### **ITEM FOR ENVIRONMENTAL COMMISSION AGENDA**

COMMISSION MEETING DATE REQUESTED:	November 7, 2018
NAME & NUMBER OF PROJECT:	All Stor Westlake SP-2017-0478D
NAME OF APPLICANT OR ORGANIZATION:	Nhat Ho, Civiltude, LLC, 512-761-6161
LOCATION:	9021 FM 2244, Austin, TX 78746
COUNCIL DISTRICT:	Not Applicable; the site is in the Austin 2-mile Extra-Territorial Jurisdiction (ETJ)
PROJECT FILING DATE:	November 22, 2017
DSD/ENVIRONMENTAL STAFF:	Pamela Abee-Taulli, Environmental Review Specialist Senior 512-974-1879, <a href="mailto:pamela.abee-taulli@austintexas.gov">pamela.abee-taulli@austintexas.gov</a>
WATERSHED:	Barton Creek Watershed, Barton Springs Zone, Drinking Water Protection Zone
ORDINANCE:	Watershed Protection Ordinance (current code)
REQUEST:	Variance request is as follows: 1. Request to vary from LDC 25-8-342 Fill Requirements to allow fill up to 11 feet.
STAFF DETERMINATION:	Staff determination is that the findings of fact have been met. Staff recommends the following condition: that the applicant provide a landscape plan, which is not required in the ETJ.

Project: All Stor Westlake SP-2017-0478D  
Ordinance Standard: Watershed Protection Ordinance  
Variance Request: Requ

ALL STOR WESTLAKE  
9201 FM 2244, AUSTIN TX 78746  
FILL EXHIBIT

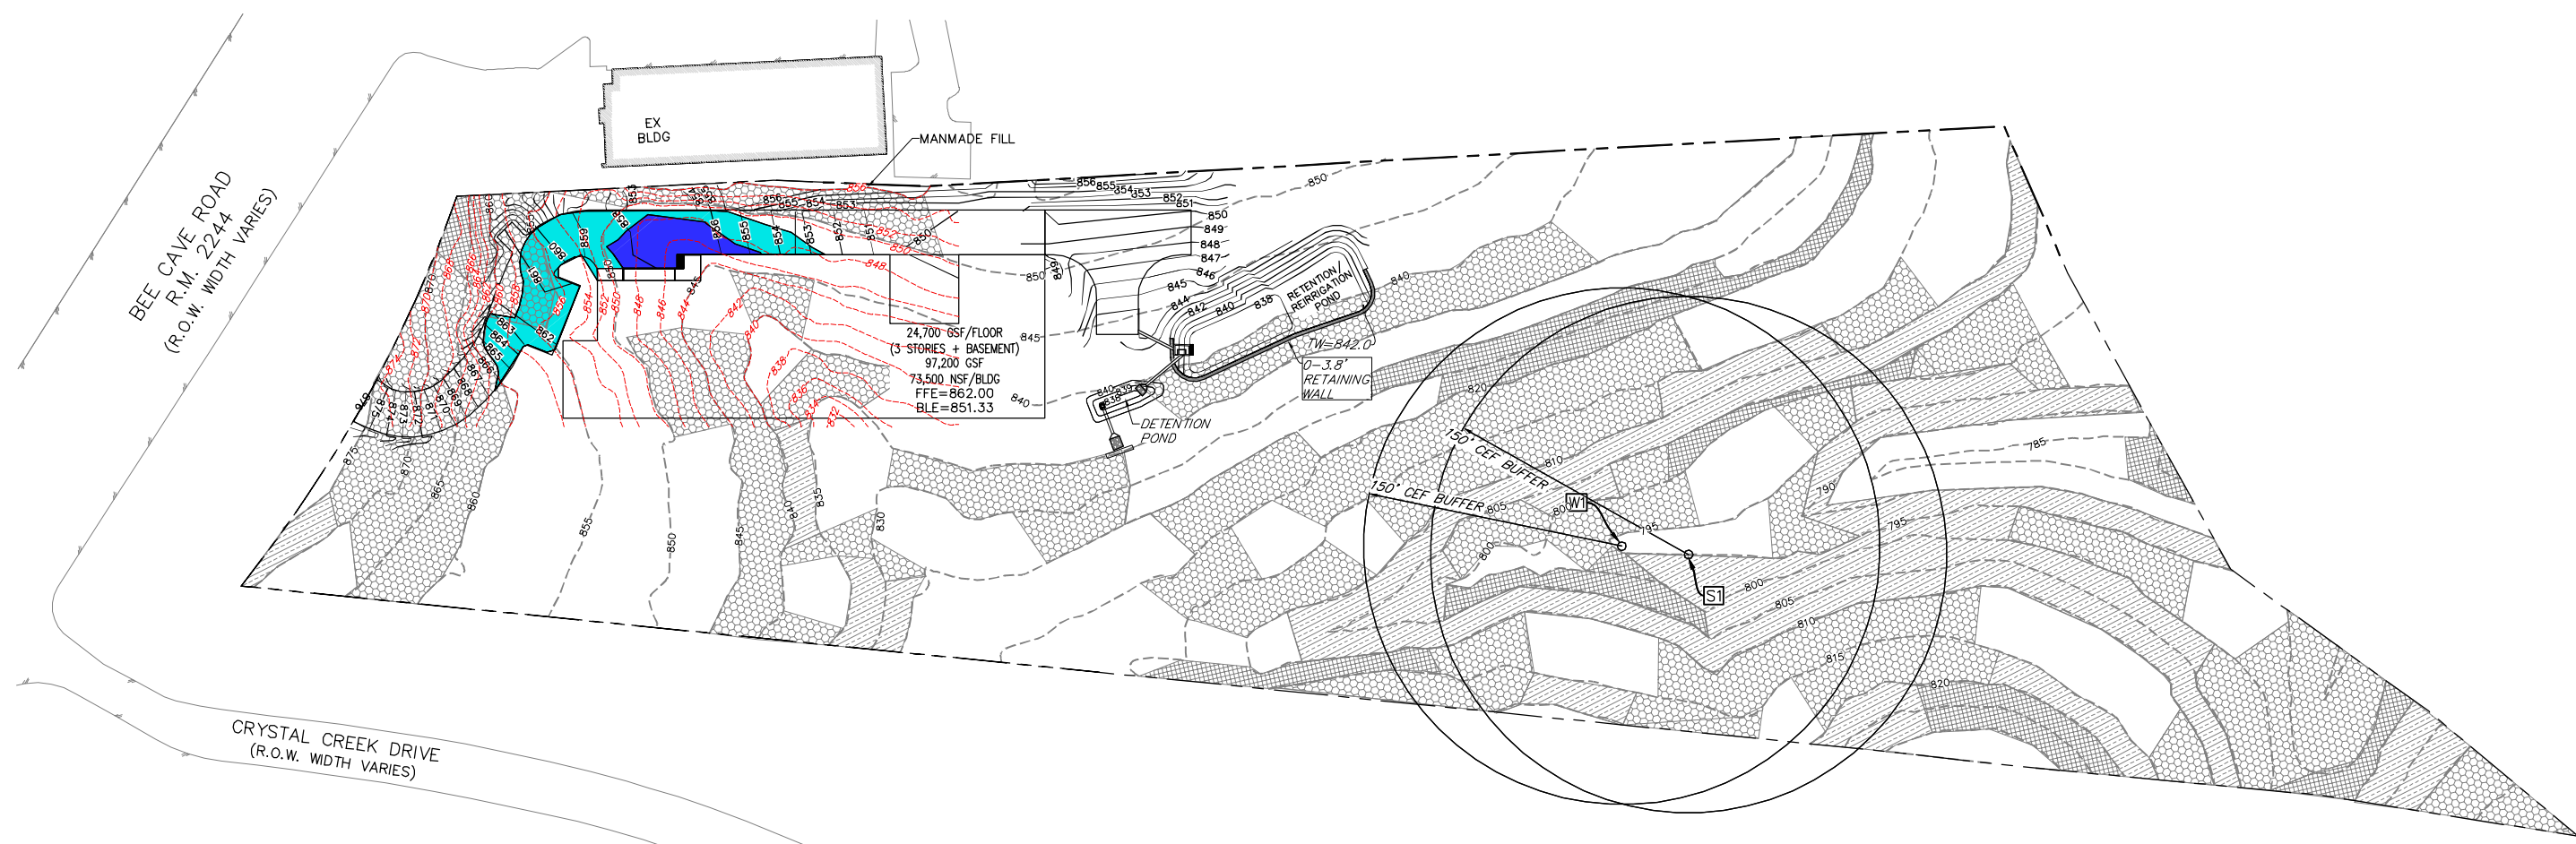
However, in order to make the access and parking compliant with ADA slope requirements, fill exceeding 4 feet is necessary.

Yes The fill is required to provide ADA compliant parking and access to the building and to provide a fire lane along the east side of the building as required by fire code.

Yes The fill for the fire lane is upslope of the building foundation, which will stabilize the fill. Fill for the parking will be stabilized by a four and a half foot retaining wall that will be constructed before the fill is placed.

Elevations Table				
Number	Minimum Elevation	Maximum Elevation	Area (Ac)	Color
1	Fill 4.00	8.00	0.10	
2	Fill 8.00	11.00	0.035
